Errata for FM28V020

Errata Number 001
Date Dec. 10, 2010
Product FM28V020-TG (32-lead TSOP)

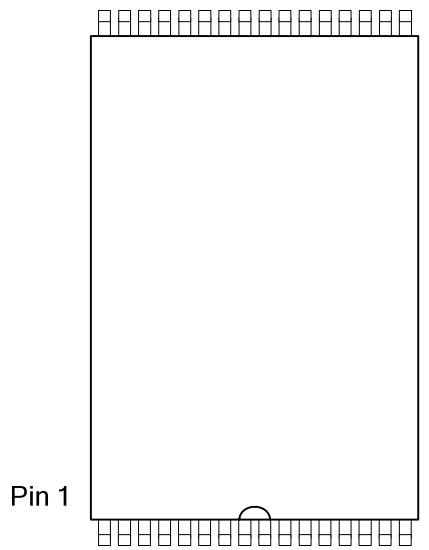
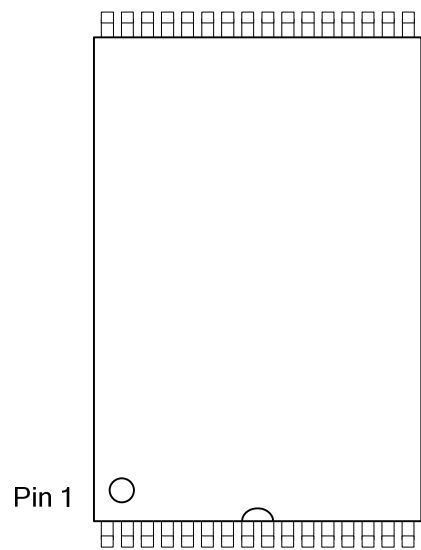
The 32-lead TSOP-I package does not have a pin 1 indicator in the corner of the package. The affected devices are marked with the date code 1001 through 1105. This problem has been fixed. The correct package marking with the pin 1 indicator dot will become available as date codes 1106 and higher.

Date Codes 1001 - 1105

Date Codes 1106 and up
